EXHIBIT P

Grand Traverse County Health Department
 2650 LAFRANIER RD
 TRAVERSE CITY, MI 49686
 231-995-6051

GT #: 36670

The 81 Development Company, LLC
The 81 on East Bay - PUD
PUD Open Space Plan
 Section 14, Town 29 North, Range 10 West
 Peninsula Township, Grand Traverse County, Michigan

Test Well

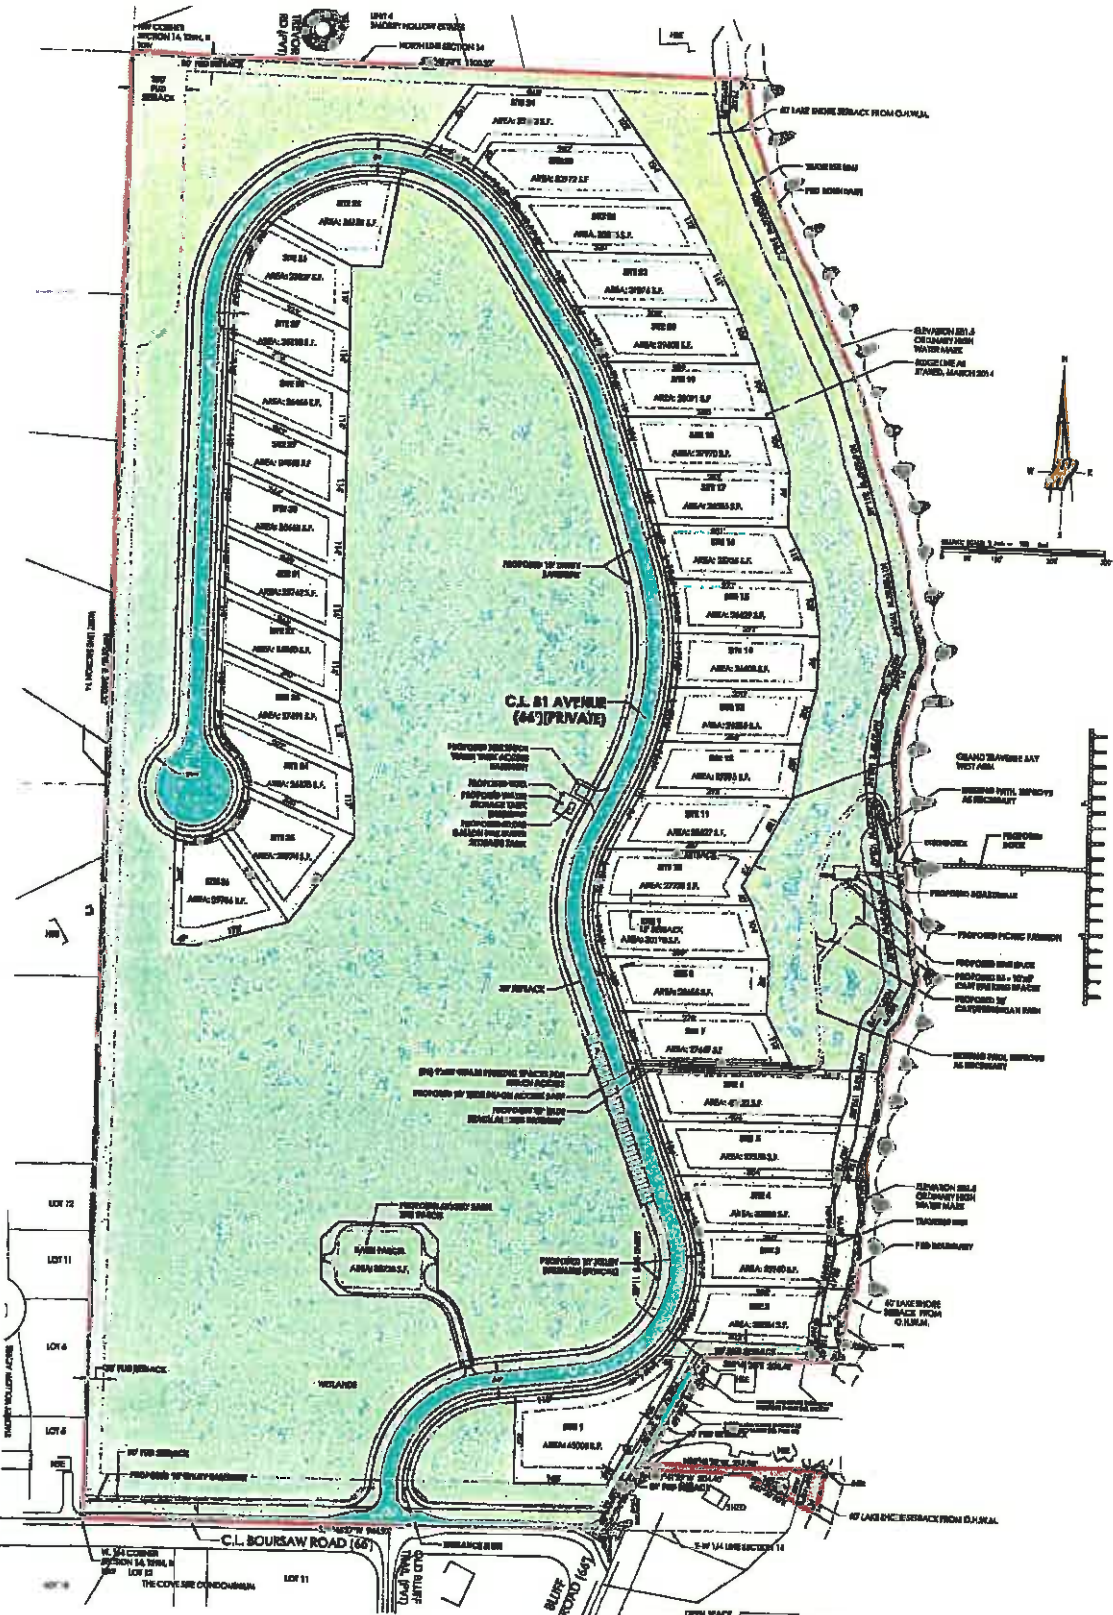
- Test well shall be drilled to a depth so that the well casing penetrates at least 10 ft. of continuous clay overburden and/or 50 ft. of submergence ~~to~~ from the static water level to the top of the screen is achieved
- A target depth of 200 ft. or greater should be considered due to a well located approximately 800 ft. to the northwest which had a known nitrate concentration of 18.9 ppm. This well was 235 ft deep at an elevation of approx. 760 ft. The test well elevation

is approx. 671 ft. The depth to the ^{water} table at the same elevation as the high nitrate well is approx. 146 ft.

- Conduct 4 hour pump test and Record Recovery time 81 AVE to original static level.

- After well is drilled, collect sample; Analyze for coliform bact, partial chemists and ARSENIC.

- Suitability of test well will be determined based on sample results and yield test.
